World Forum for Harmonization of Vehicle Regulations

Working Party on Passive Safety

Regulation No. 100 (Battery electric vehicle safety)**Proposal for the 02 series of amendments****Submitted by the Chair of the group of interested experts on Rechargeable Energy Storage Systems (REESS) ***

"Figure 1

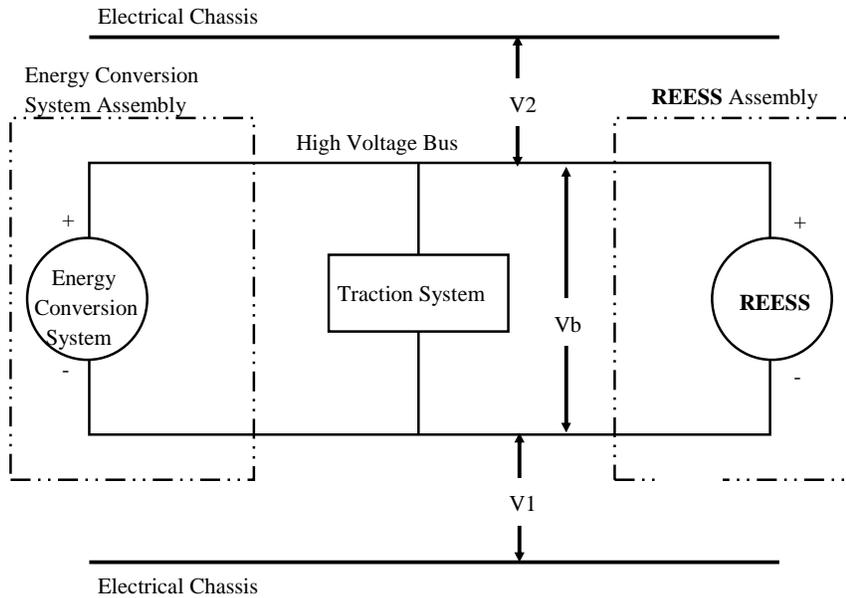
Figure 1, amend to read:

Measurement of V_b , V_1 , V_2

"Figure 2

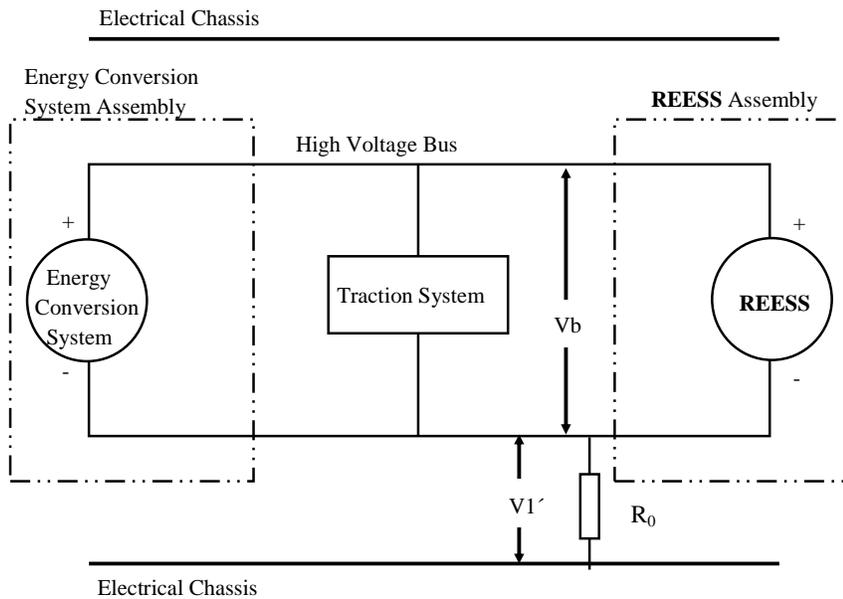
Figure 2, amend to read:

Measurement of V_1'

"Figure 3
Measurement of V_2'

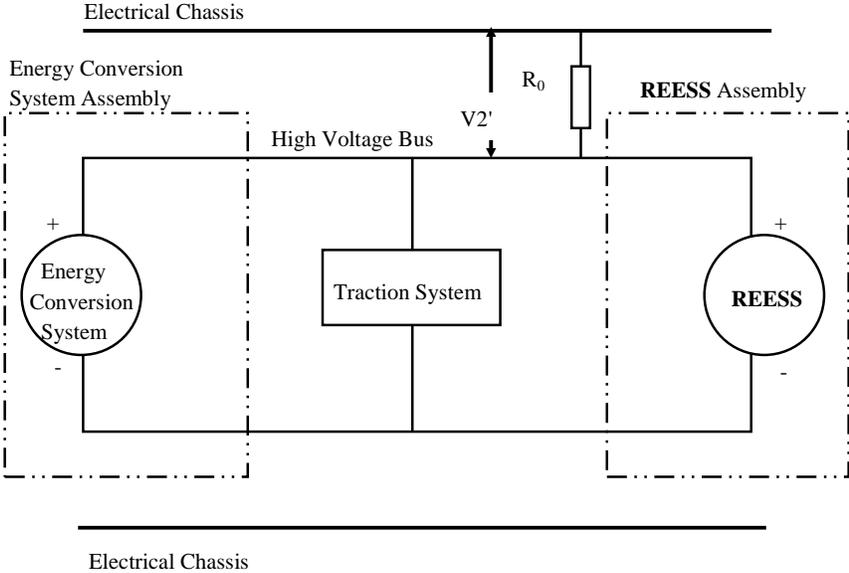
Figure 3, amend to read:

"Figure 7.1.

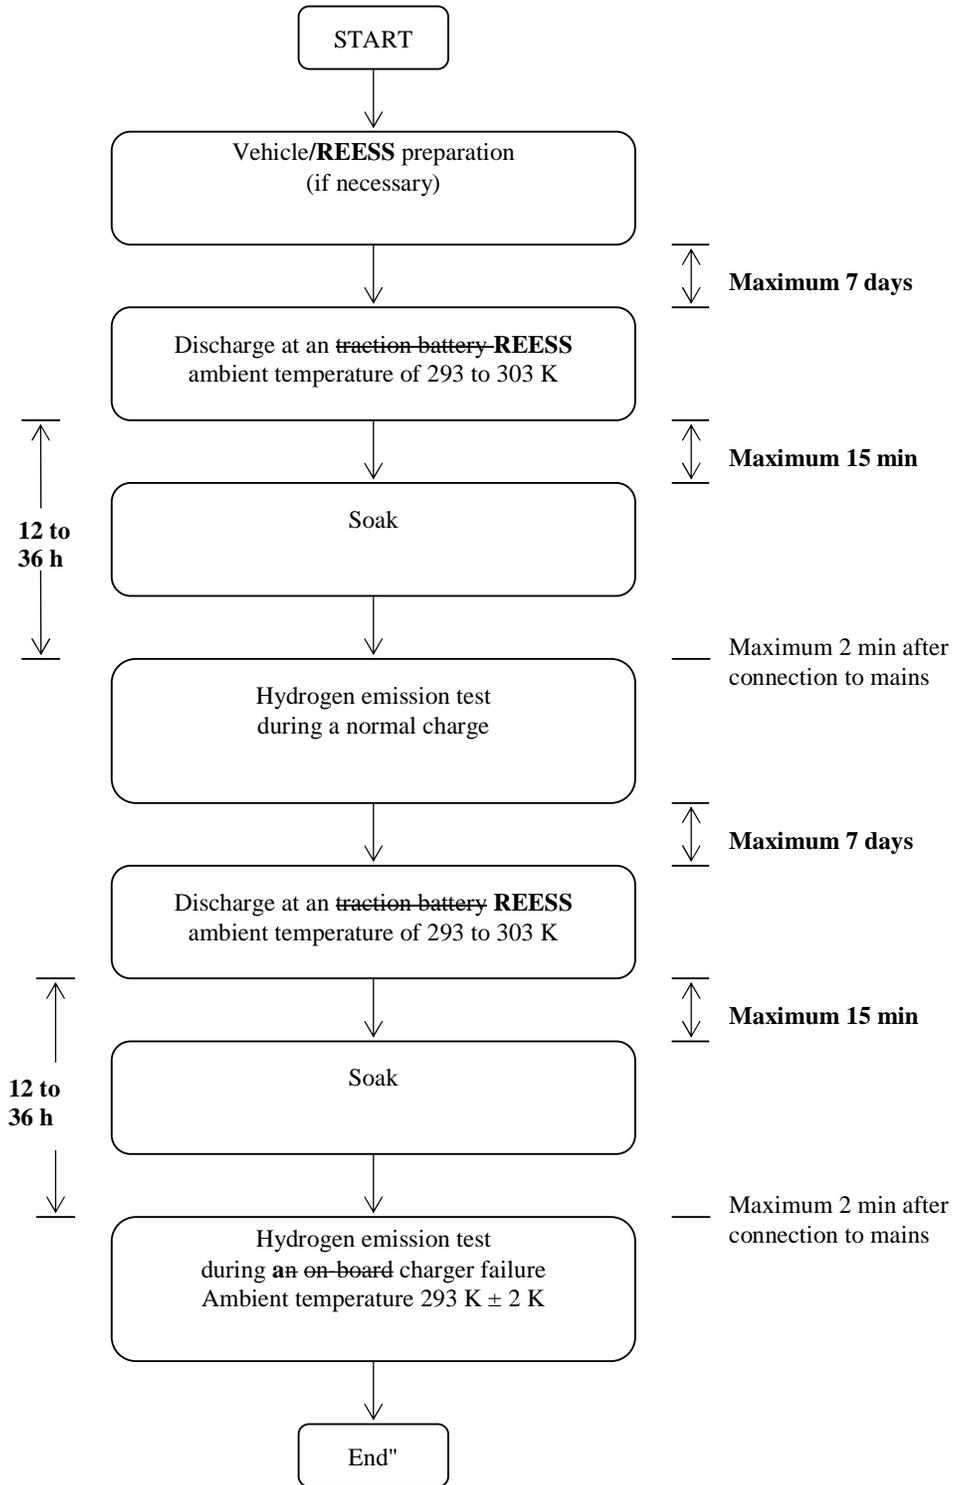
Figure 7.1., amend to read.

Determination of hydrogen emissions during the charge procedures of the ~~traction battery~~ **REESS**
